August 19, 1992

**TO:** Daron Haddock, Permit Supervisor

**FROM:** Rick P. Summers, Senior Hydrologist

**RE:** Review Pond C Designs, Amendment 007/019-91A and Response to Division Order 007/019-92A, (Received March 9, 1992), Andalex Resources, Inc., Centennial Project, ACT/007/019, Carbon County, Utah

# STAGE VOLUME CURVE

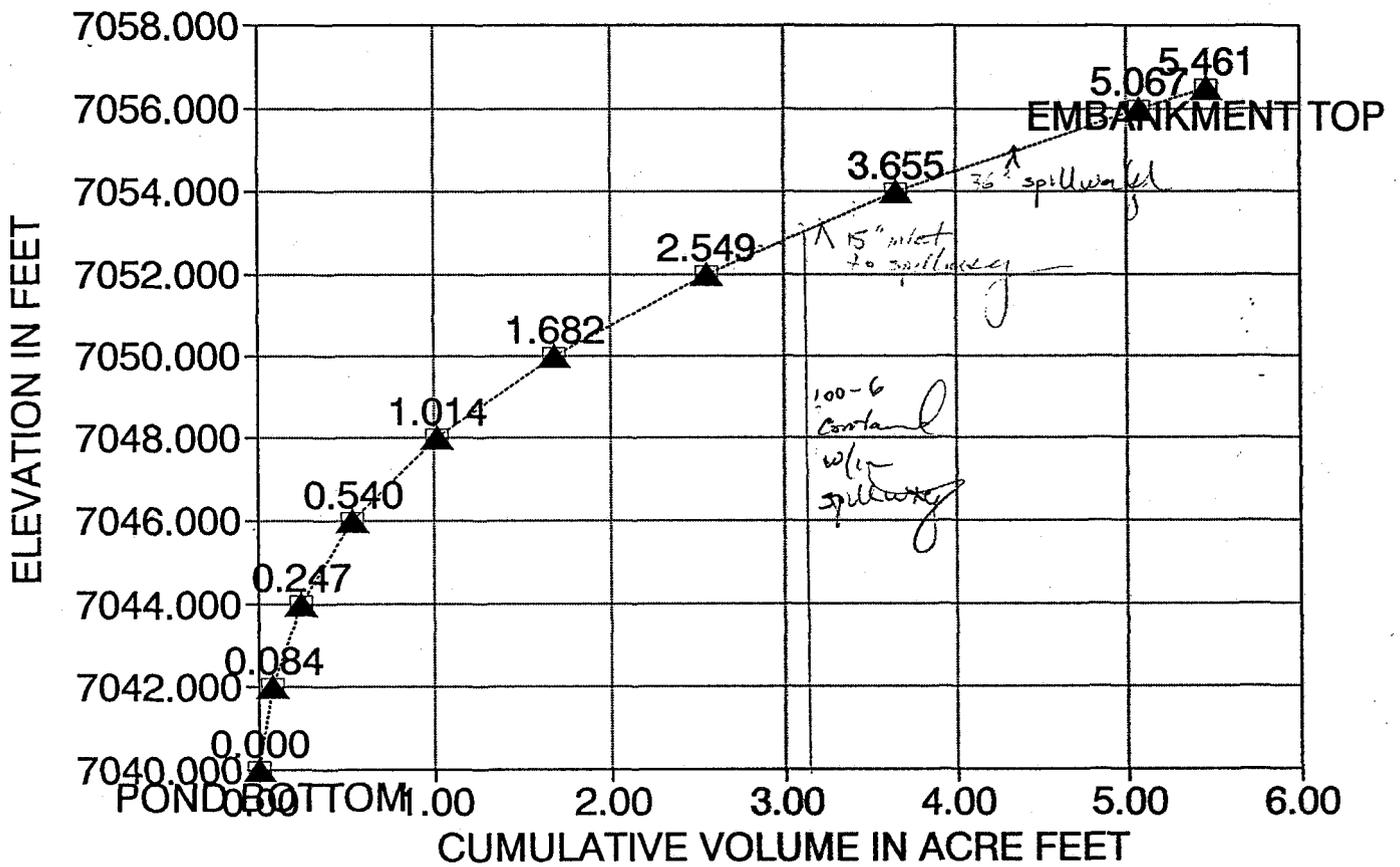
The first criteria to be met for the exemption from 742.223 relates to storage criteria requirements. For sedimentation Pond C at the Centennial minesite, the ammendment demonstrates that the pond is adequately sized to totally contain both the 10 yr. - 24 hr. and the 100 yr. - 6 hr. precipitation events. A review of the precipitation records at the Price City station indicates the 10 yr. - 24 hr. precipitation depth is 1.82 inches, the 25 yr. - 6 hr. event is 1.5 inches, and the 100 yr. - 6 hr. event is 1.91 inches. The Operator has provided runoff volume calculations and a stage-volume curve demonstrating compliance with this rule. Division calculations verifying the demonstration are attached to this memo. The current spillway at Pond C has also been demonstrated to be sized adequately to pass the 25 yr. - 6 hr. and 100 yr. - 6 hr. precipitation events with 0.8' and 0.5' freeboard respectively. This freeboard is marginal, however, the spillway is equipped with an 18" inlet located 1.5' below the inlet to the overflow. The discharge capacity of this inlet was ignored during the demonstration, therefore, the estimates of the spillway capacity are conservative and the freeboard will actually be greater than those values.
